## SERVICE BULLETIN

SB-050718 REV A

**DATE ISSUED:** 5/18/2018  
**DATE EFFECTIVE:** 5/18/2018  
**SUPERSEDES NOTICE:** N/A  
**SUBJECT:** Torque verification on vertical tail forward attachment bracket and aft pitch pulley pivot bolt

**AIRCRAFT AFFECTED:** **MODEL:** ICON A5  
**S/N:** 00022-00027

Figure 1: View of the vertical tail with the horizontal tail removed

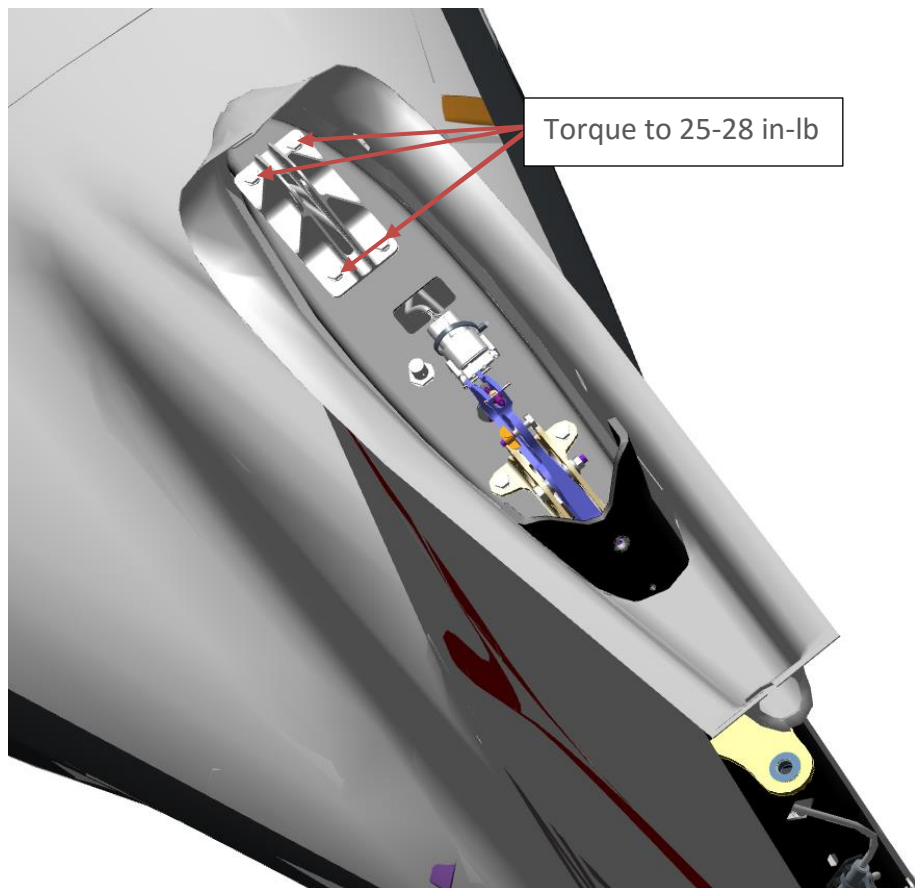
ICON is committed to designing, manufacturing, delivering, and supporting a high quality Light Sport Aircraft, providing a level of safety well beyond expectations. Recently received production quality issue reports indicated that the horizontal tail attachment bracket and aft pitch pulley pivot hardware may be under torqued. Inspection of several aircraft has shown that the horizontal tail attachment hardware were slightly under torqued but clamped to the vertical tail rib. Additionally, the aft pitch pulley pivot bolt was also found slightly under torqued but clamped to the attachment bracket. Verify correct torque on the forward horizontal tail attachment bracket attachment hardware and aft pitch pulley pivot bolt.

1. Torque all four forward horizontal tail bracket to vertical tail attachment hardware to 25-28 in-lb as shown below in Figure 1. Prior to torquing mark all bolts then back them off by one-quarter turn, then proceed to torque them to the set value.
